NEW YORK HARBOR
CHANNEL NAVIGATION IMPROVEMENT 50 FT PROJECT
AMBROSE CHANNEL

CONTRACT2
S–AM–1
W912DS–05–B–0012

Symbol	Description	Date	Rev.
4	Sheet C-35 and C-37 are eliminated and sheet numbers are rearranged accordingly. I thru 35 and Alignment Data sheet All Plan Sheets and Cross sections sheets are revised.	7/19/05	G.A.

COVER SHEET,GENERAL PLAN AND INDEX TO DRAWINGS

ALIGNMENT & REFERENCE LINE DATA SHEET

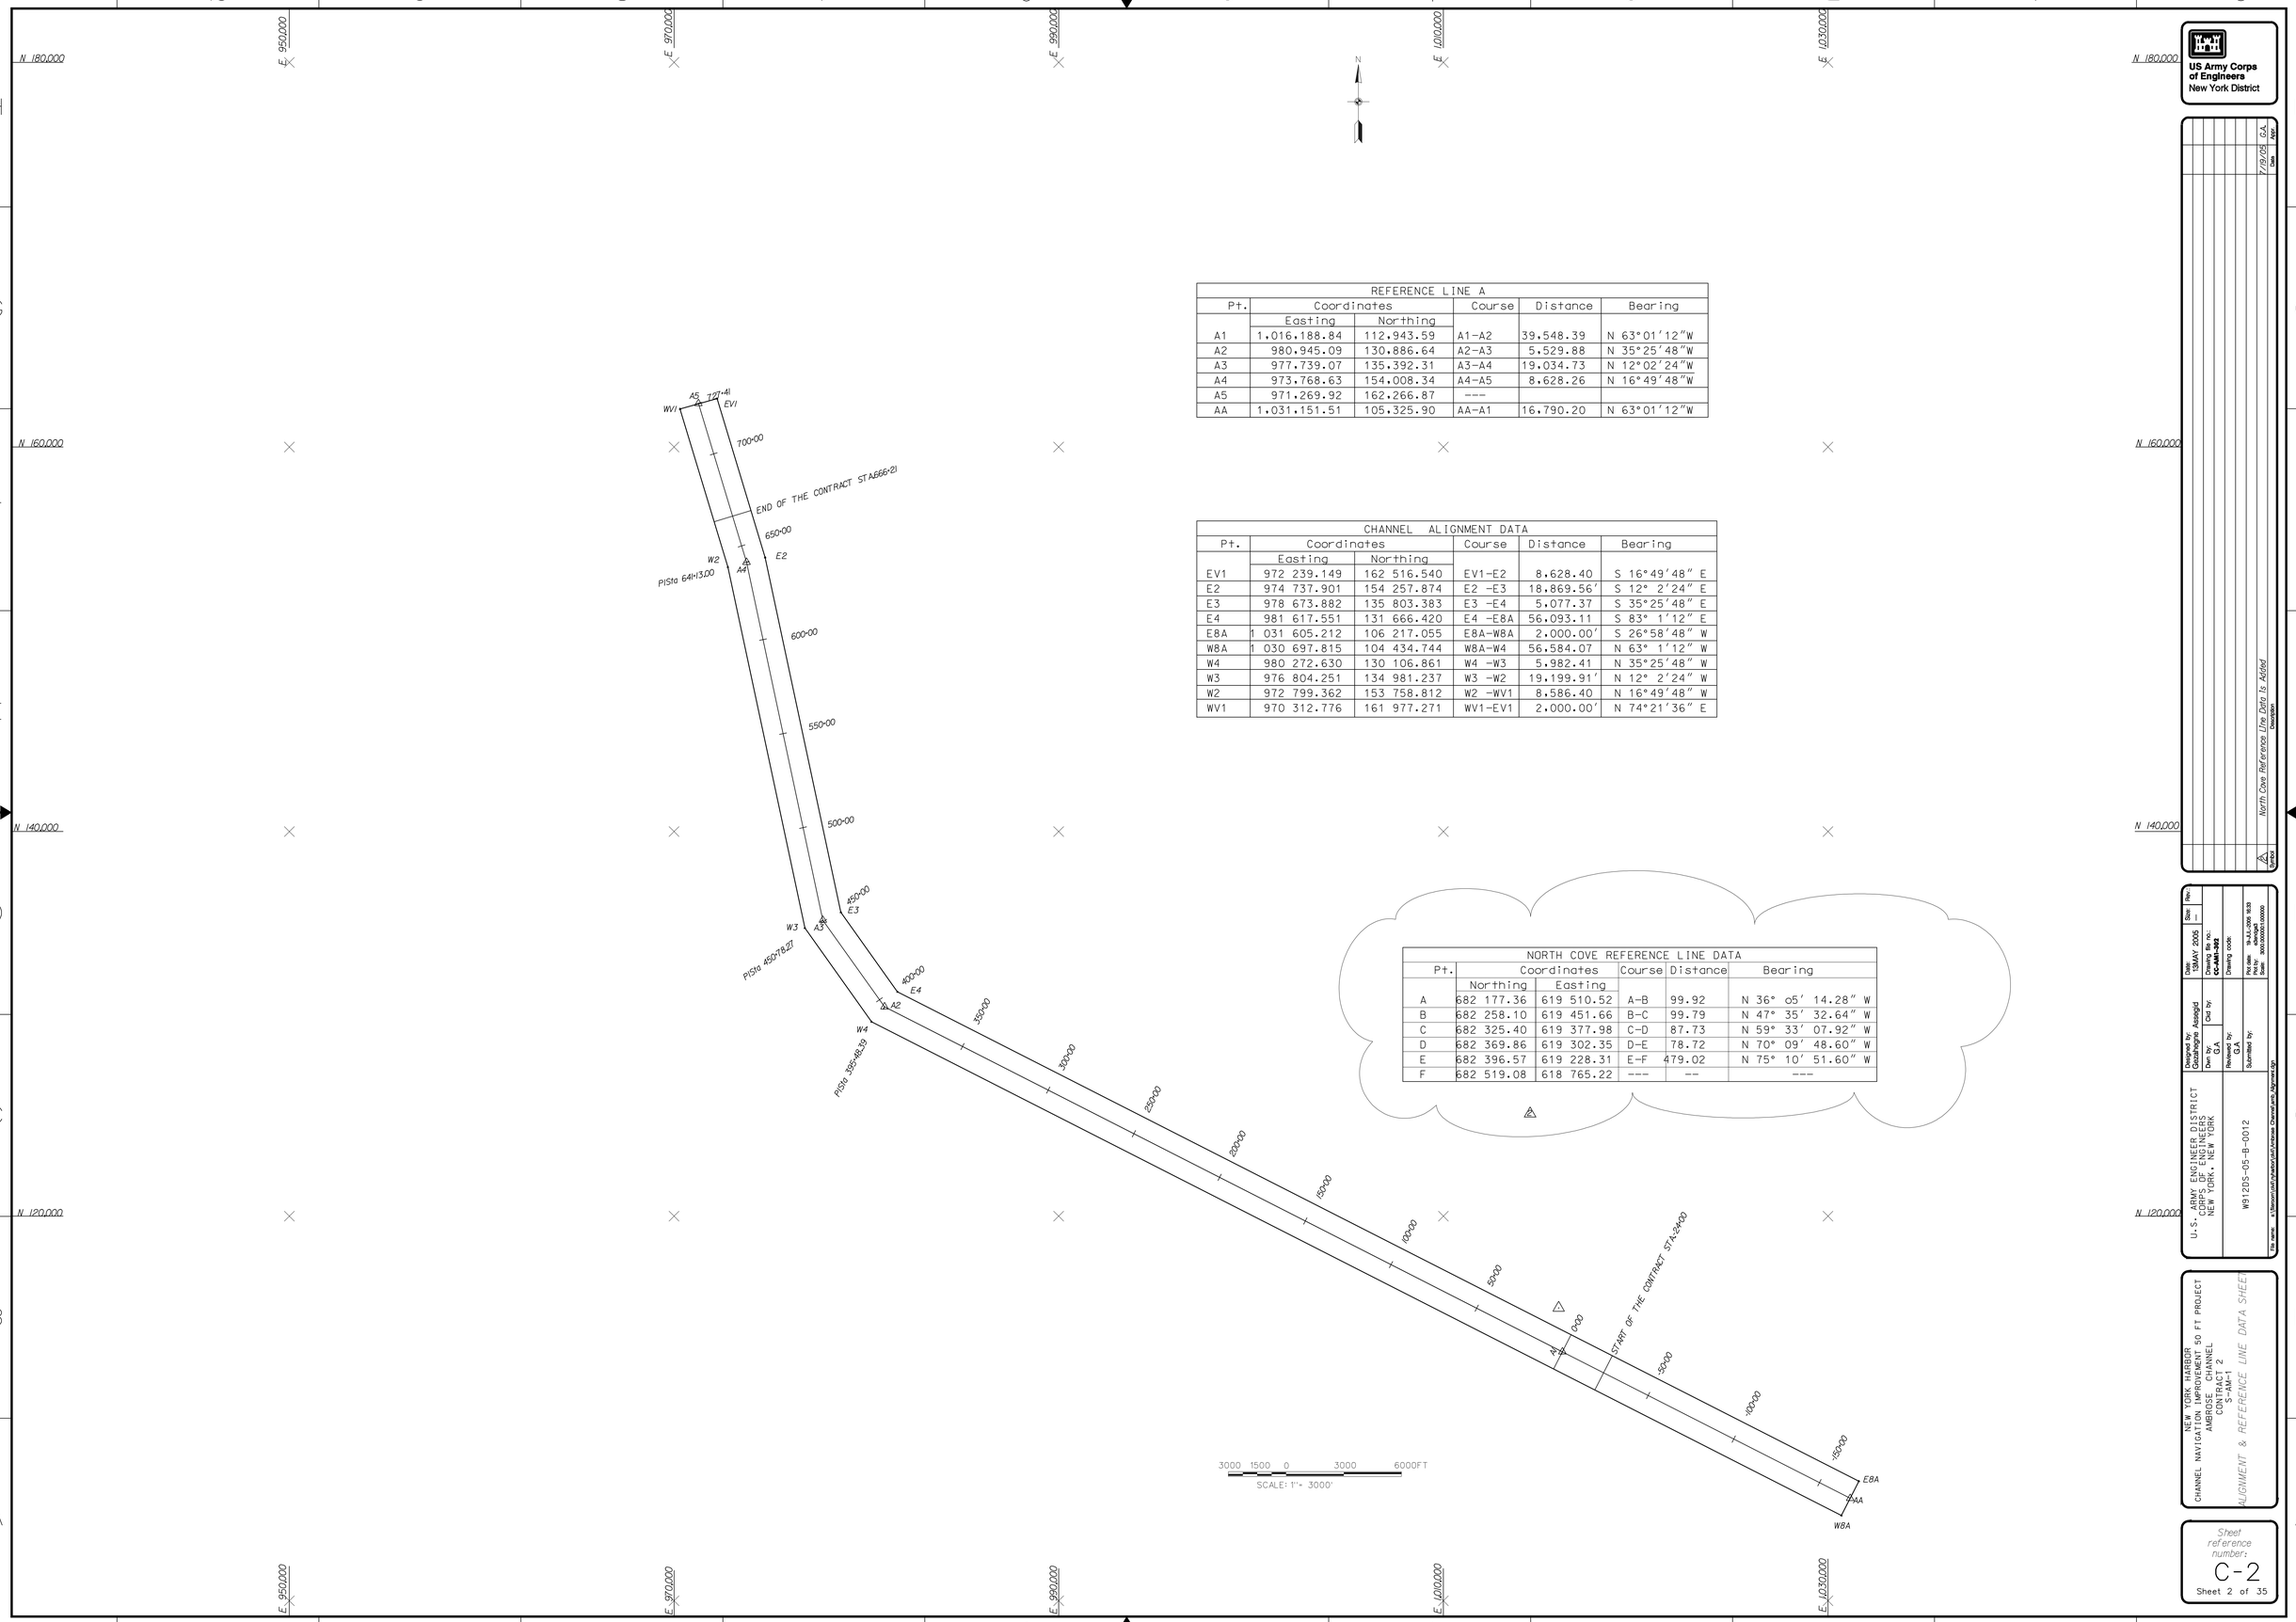
North Cove References Line Data Is Added

PLAN SHEET STA.A1+62.6 TO STA.U12+76.5

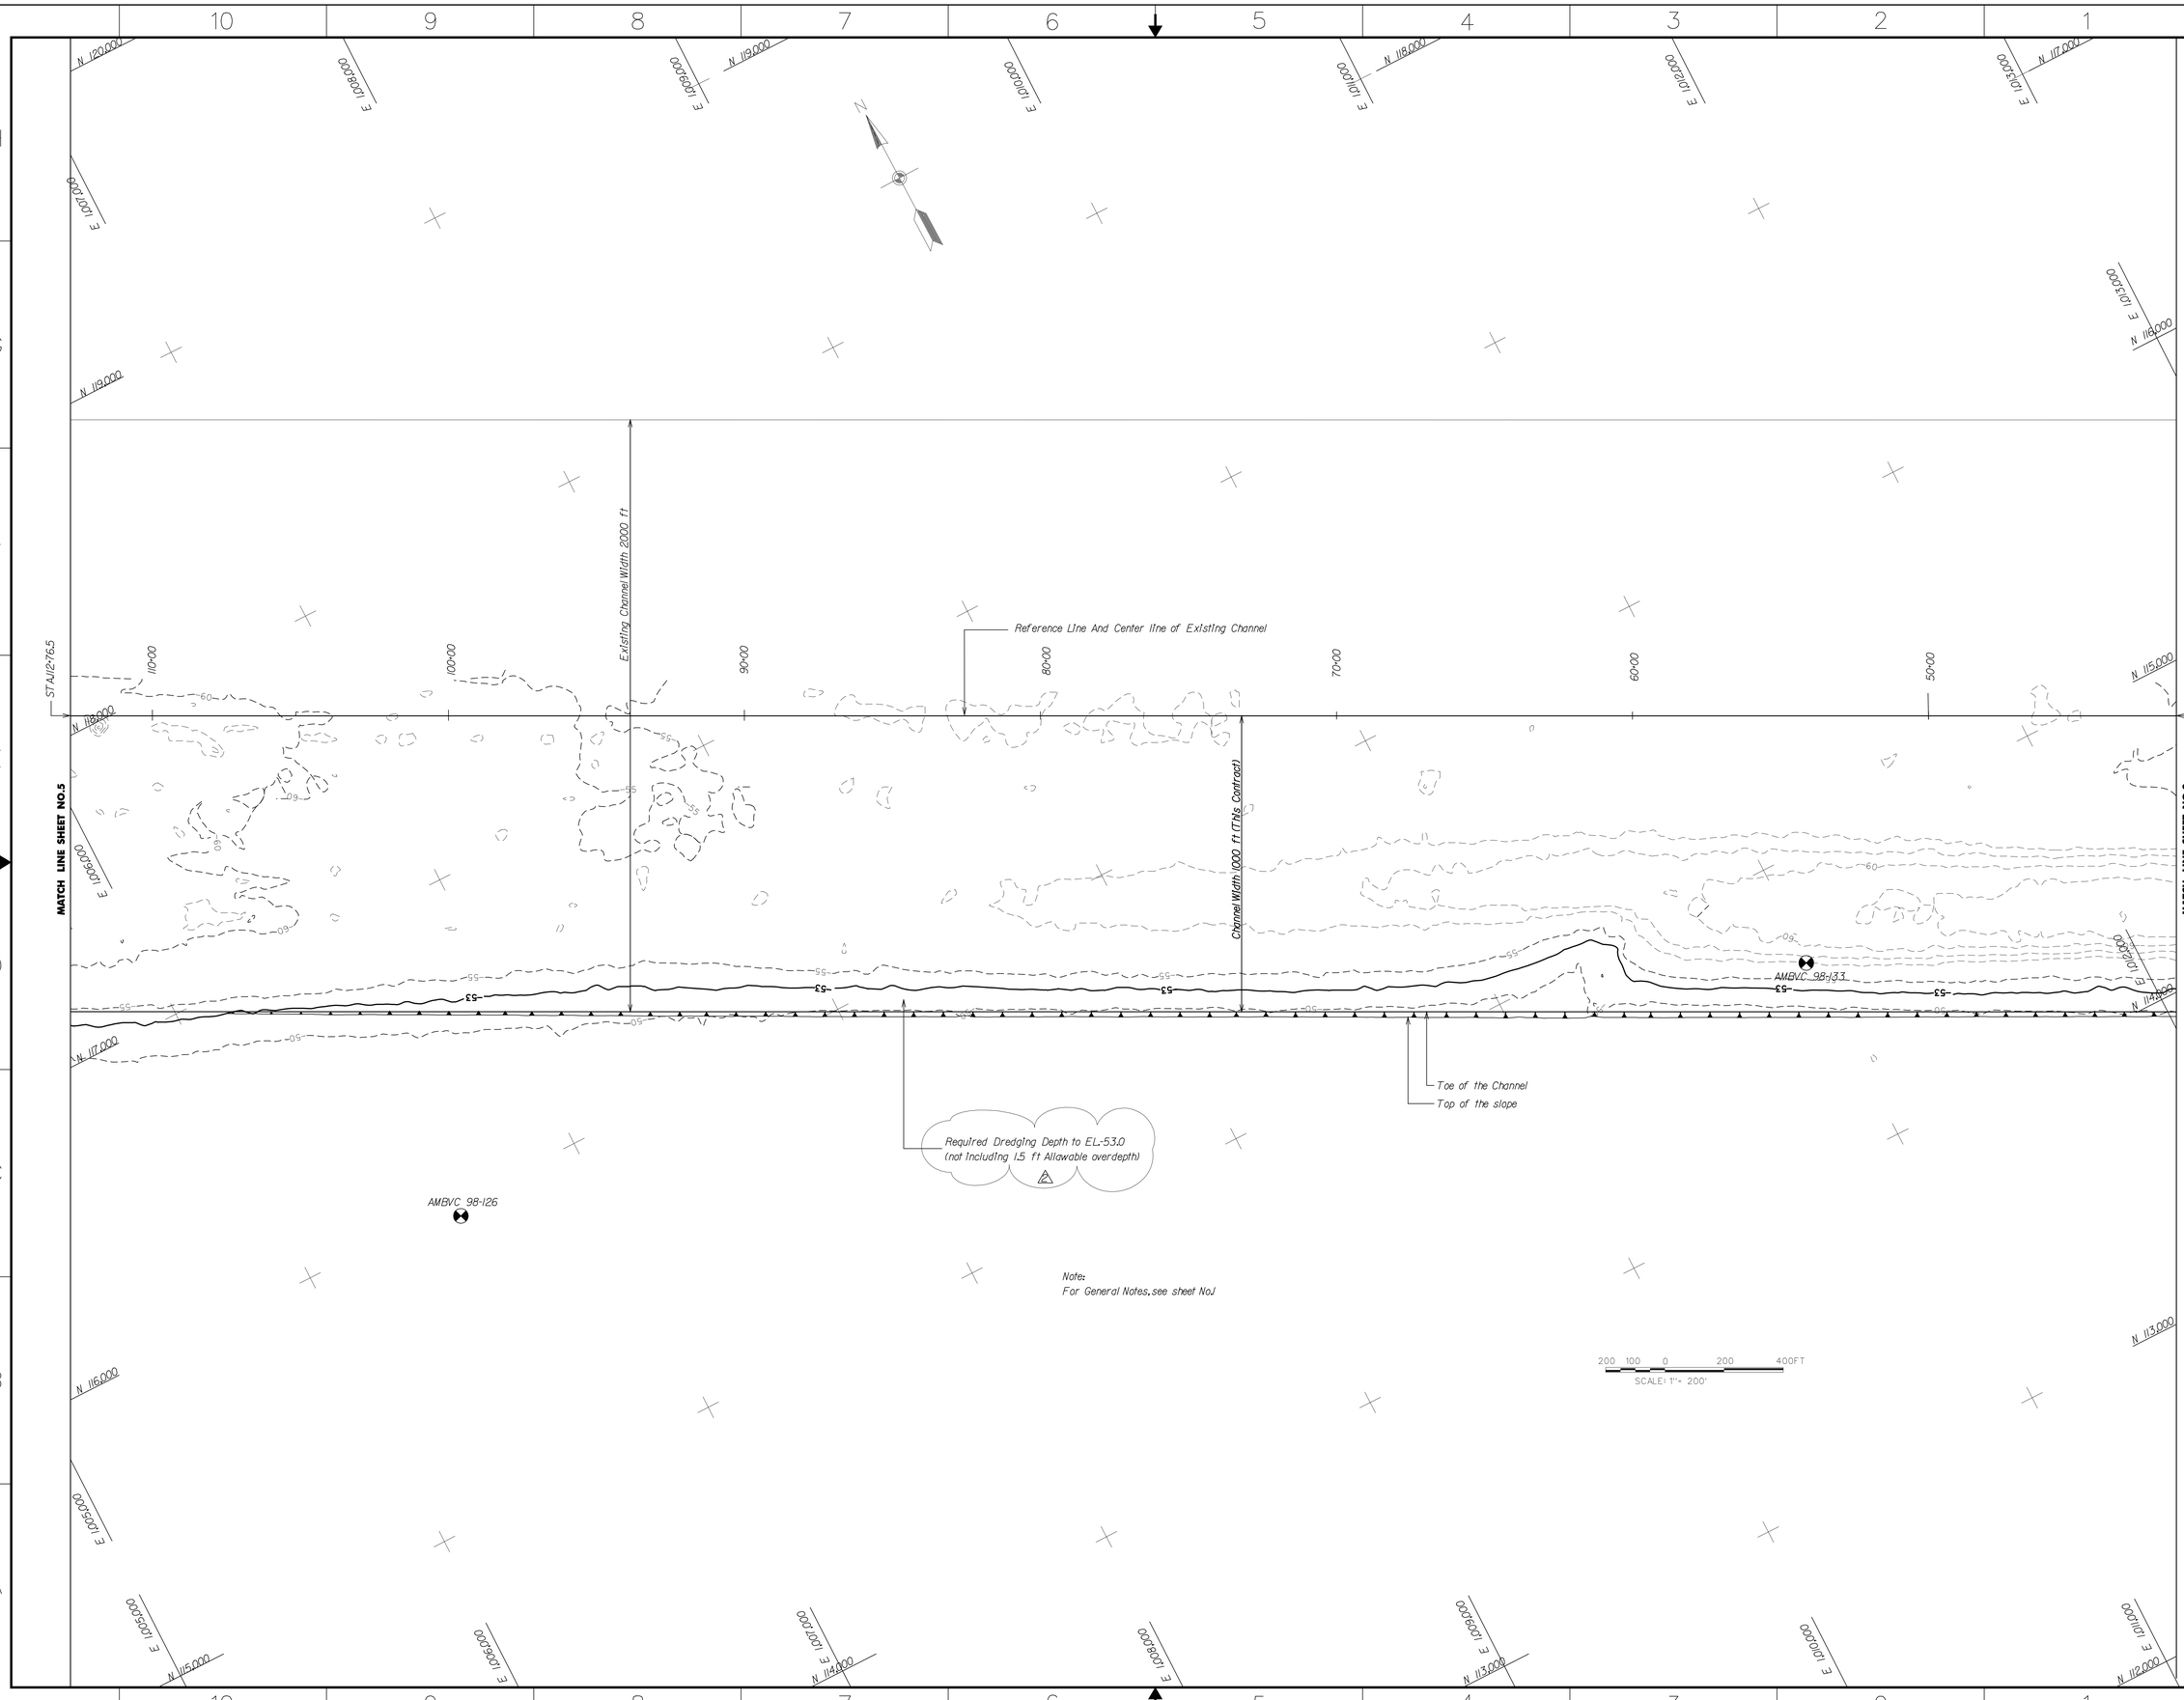
Rev.	Date	Description
A	7/19/05	G.A. Revised Allowable Overdepth

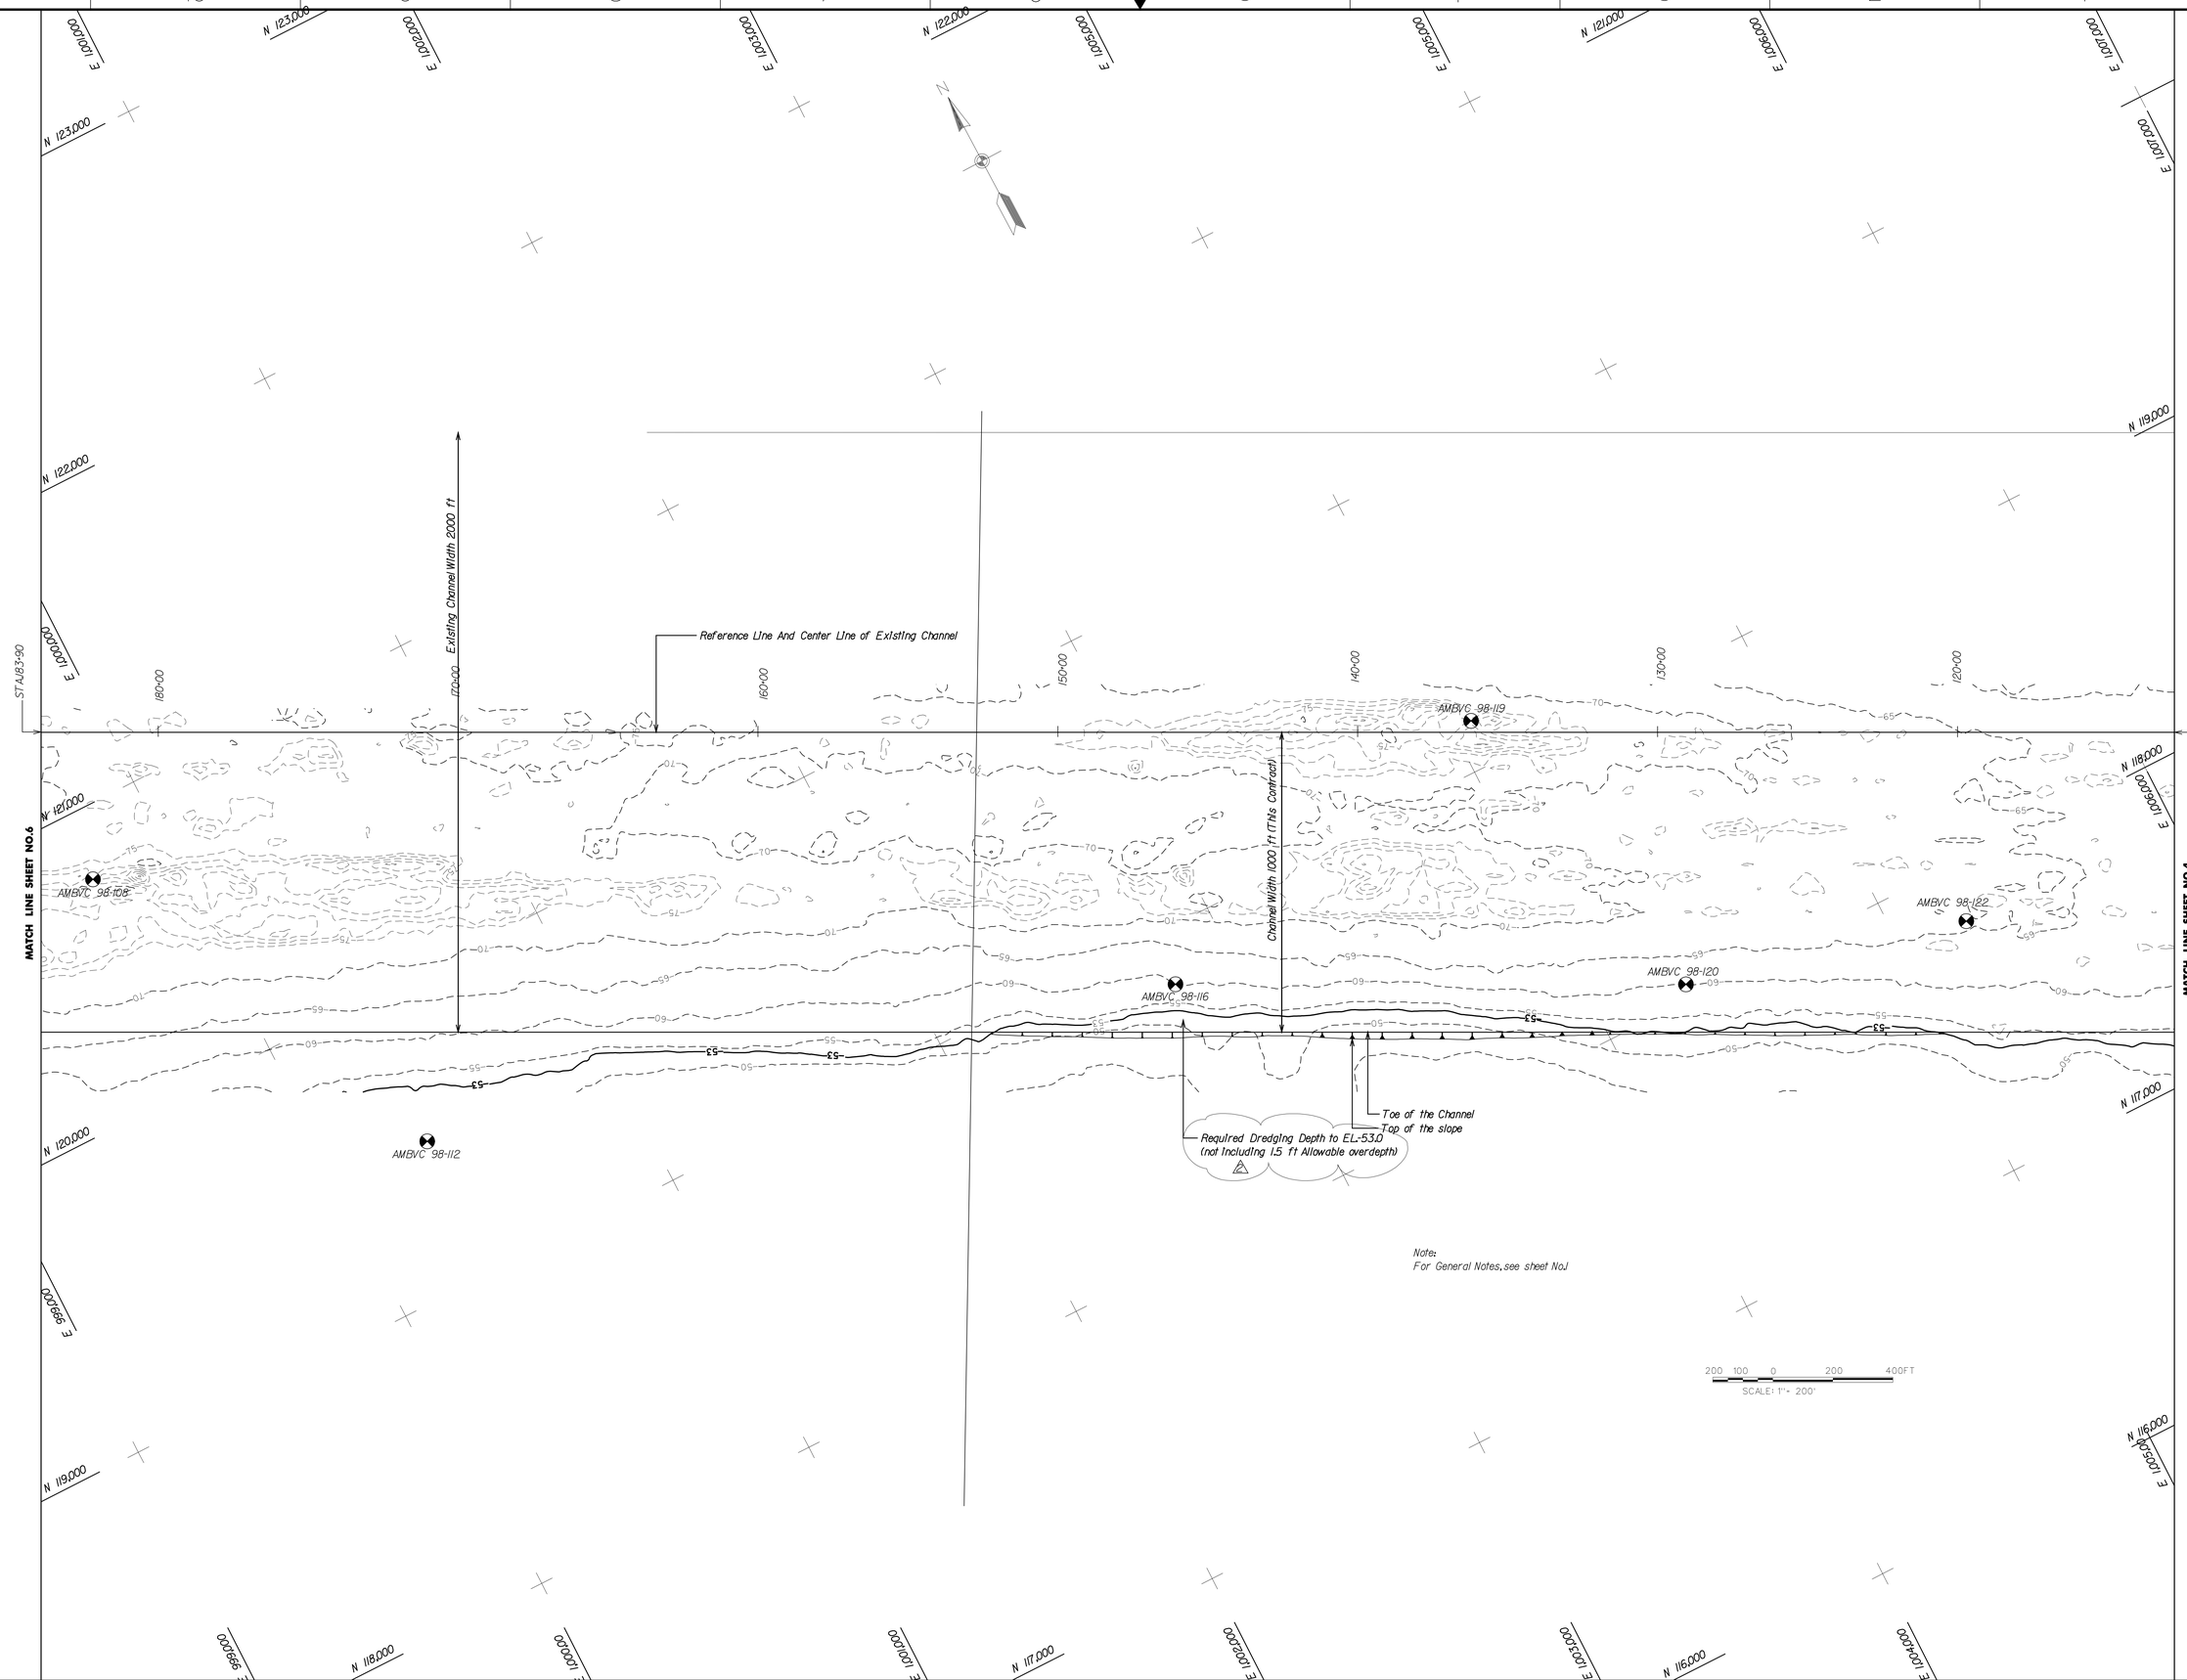
Sheet reference number:
C-5
Sheet 5 of 35
Revised Allowable overdepth
Date: FEBRUARY 2006
Size: 1
Rev.
Drawing file no.: CC-AMA-S03
Drawing code:
Plot date: 19-JUL-2006 16:24
Plot by: eJenkgs3
Scale: 200000000:1000000
Designed by: Consultants Assegid
Drawn by: G.A.
Checked by:
Reviewed by: G.A.
Submitted by:
File name: S:\Navcon\cad\Windsor\Outlook\crosses Channel\ana_01.dgn
